EAO Response to Data Gaps

This document has been prepared to respond to data gaps identified by the Bureau of Land Management (BLM), Vernal Field Office regarding Enefit American Oil's (EAO) utility corridor and Dragon Road improvement right-of-way (ROW) application pertaining to the BLM's Utility Corridor Project Environmental Impact Statement (EIS). Data gaps were transmitted by the BLM in two files – one specifically addressing gaps in baseline data (*EPG-BLM_BaselineReport_DataGapReview_12-29-14_trackchanges.docx*), the second specifically addressing gaps in EAO's Detailed Plan of Development (DPOD; *EPG-BLM_POD_DataGapReview_11-12-14.docx*). Data gaps were identified for the utility corridor portion of the application ("the Utility Corridor Project"), although responses below also refer to EAO's private land development ("the South Project"). Comments are addressed below accordingly and organized by data gap filename, original document/section (where provided by BLM), data gap text, and EAO response. It should be noted that the source documents will not be reissued as subsequent revisions; rather, all responses will be directly addressed herein.

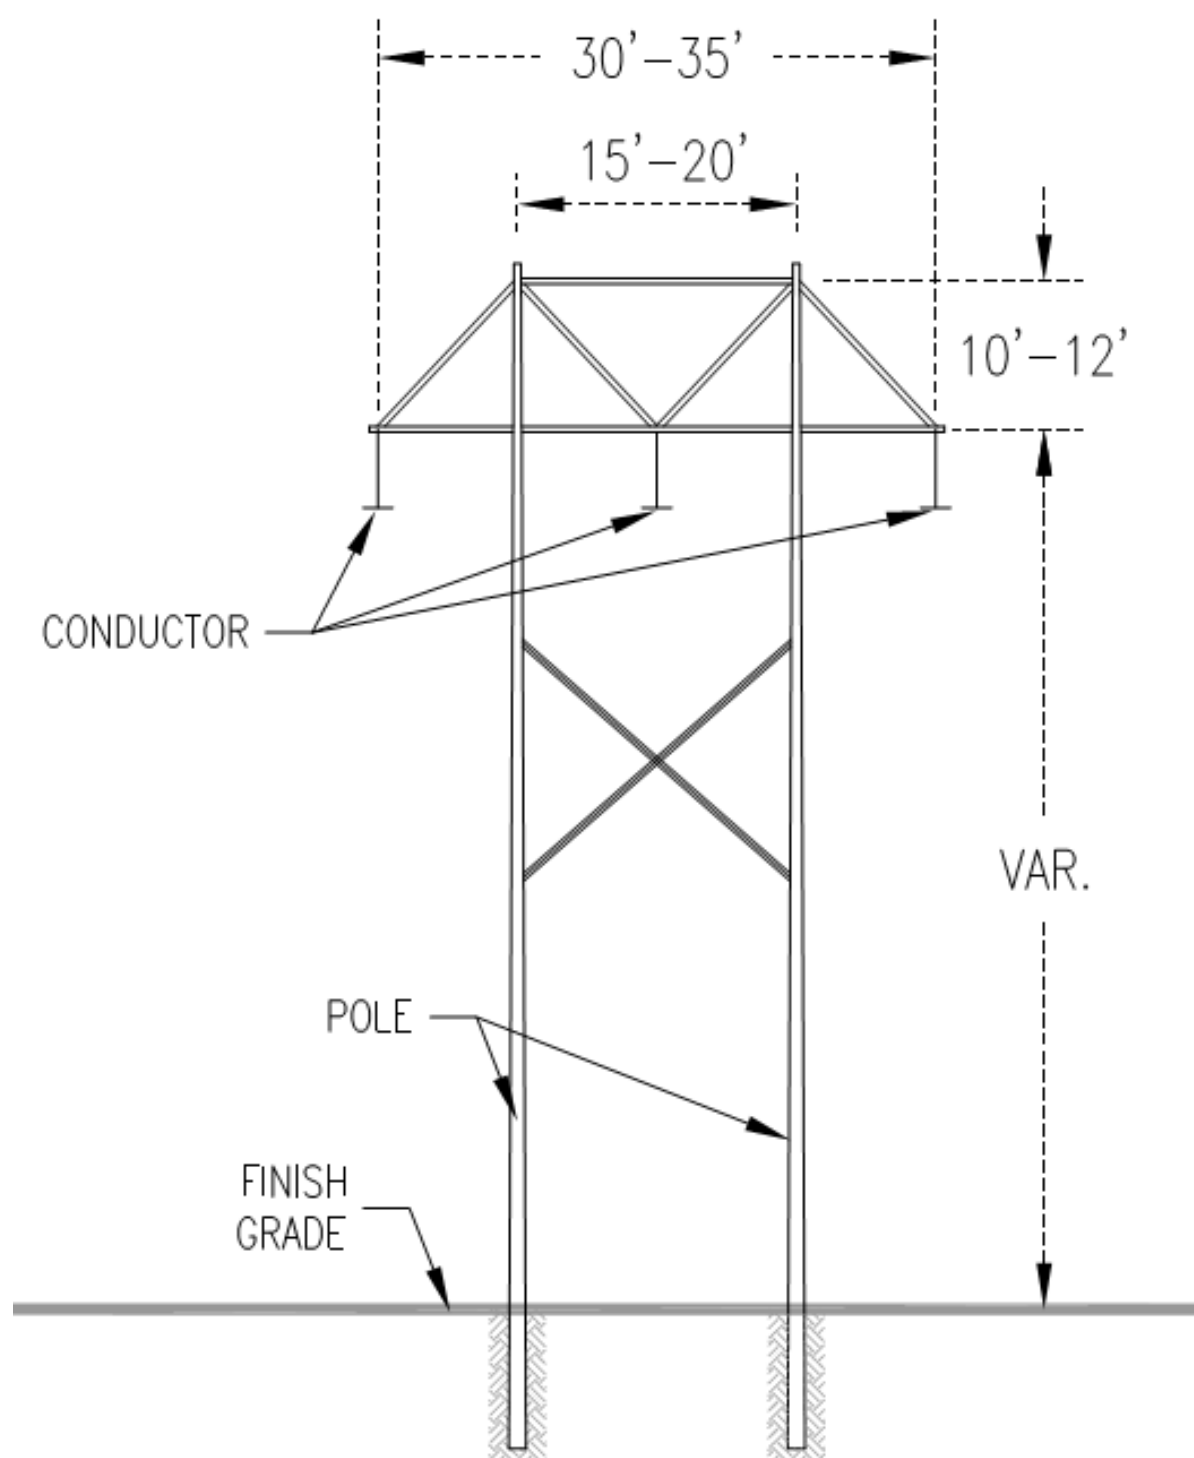
“Self-supporting steel towers and guyed structures are mention in this section but not previously as part of the project description. Please provide diagrams and details in Section 4.2.

See EAO Response to Data Gaps – Data Gap No. 40

More information from right-of-way engineering required.” (DPOD Section 5.1.10.1)

Transmission tower descriptions are provided in Data Gap Response No. 8 above. Steel towers would only be used for dead-end structures or for long spans (e.g. the White River crossing). A typical drawing of a tangent wooden H-frame tower for a 138-kV transmission line is provided below.
